Item #2:
Report Of The March 21, 2011 AC Meeting

**AGENDA
ARCHITECTURAL COMMISSION
REGULAR MEETING**

CONCERNS: Long Grove Pavilion

ITEM #4: For the ARCHITECTURAL COMMISSION on MONDAY, March 21, 2011 @ 7:00 P.M.

Figure 3 – Pavilion Plan Views

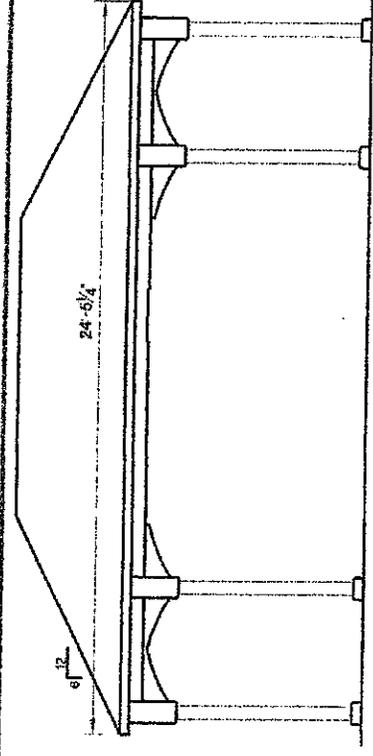
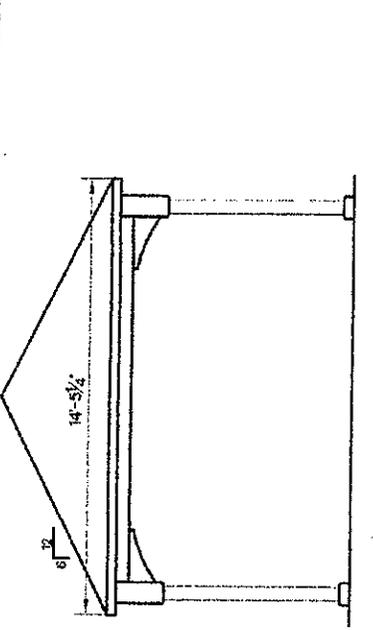
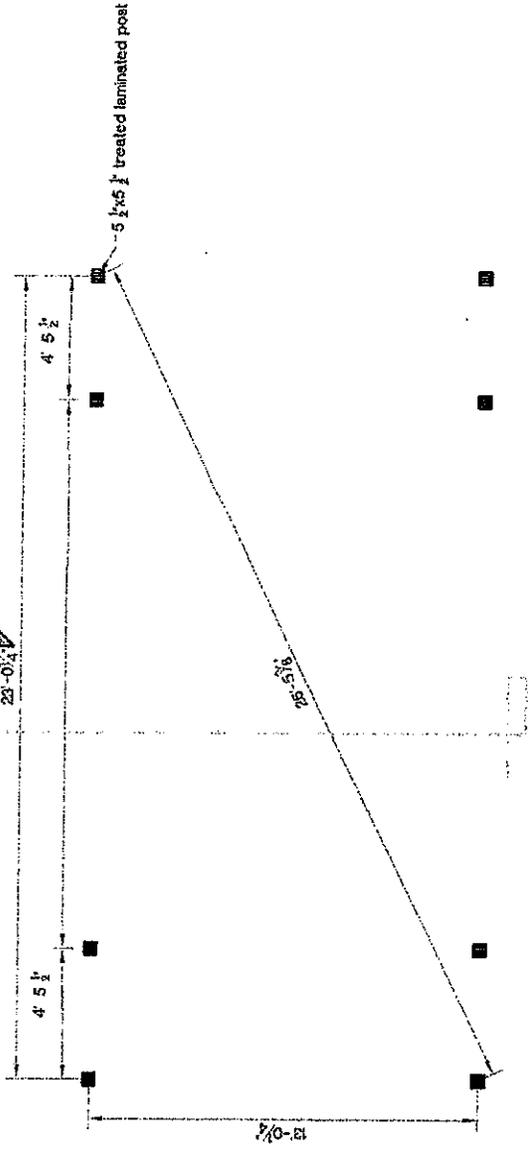
As proposed a pavilion structure measuring 14' x 24' is being contemplated as an addition to Archer Parking Lot. Elevations, a photograph and site plan of the proposal (Figures 1, 2, & 3) are attached for the consideration of the AC.

While the benefits of locating the structure as proposed seem positive, there are a multitude of zoning and policy issues associated with this proposed location. The task of the AC is to once again evaluate the look of the structure in relation to character of the downtown area and to be particularly concerned with the zoning and policy issues associated with the request. If these issues cannot be resolved then the structure cannot be built as proposed.

Aside from the zoning issues the AC should review the proposed pavilion structure as it relates to the overall character of the historic downtown. No specific standards are identified for such structures other than the general parameters of the “Long Grove Style” as found in the Village Code (attached) and the “Downtown Design Guidelines” (excerpts attached).

Figure 4 – Pavilion "Sunset Foods" Sign

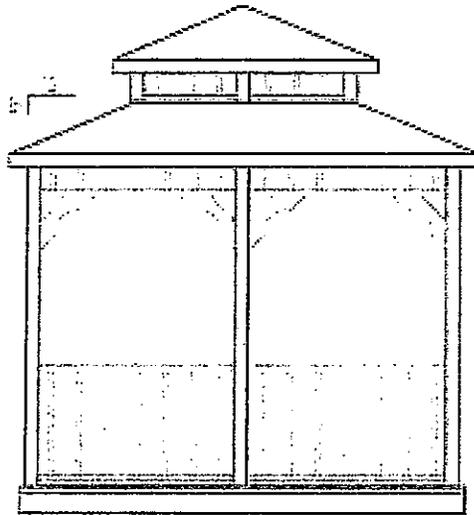
This request also includes a request for signage as attached in Figure 4. The sign will be constructed of one-half inch non-expanded PVC with a routed digitally printed logo. The sign will be laminated and ground mounted on posts. The sign will be brown, grey with black lettering on a cream background. The overall design of the sign will consistent with the pattern for signage contemplated for the entire downtown once funding is available for such signage. This design for signage was created as an offshoot to the Downtown Master Plan and Design Guidelines process.

The sign may be considered a “directional and warning sign” which is permit exempt if the sign contains 2 square feet of copy area. Per the Village Code sign area is calculated as follows;

Using this definition staff calculates the area of the sign at 3 square feet. To qualify as a “directional and warning sign the “area” would need to be reduced by 1 square foot. Please note the 2’ x 3” dimension refers to the area of the entire sign face and does not exclude perimeter or framing elements of the sign face.

If the proposed signage is reduced to two (2) square feet then the sign may be considered a “directional and warning sign” which is permit exempt but is being brought to the attention of the AC with regard to the overall implementation of the Downtown Master Plan and Design Guidelines.
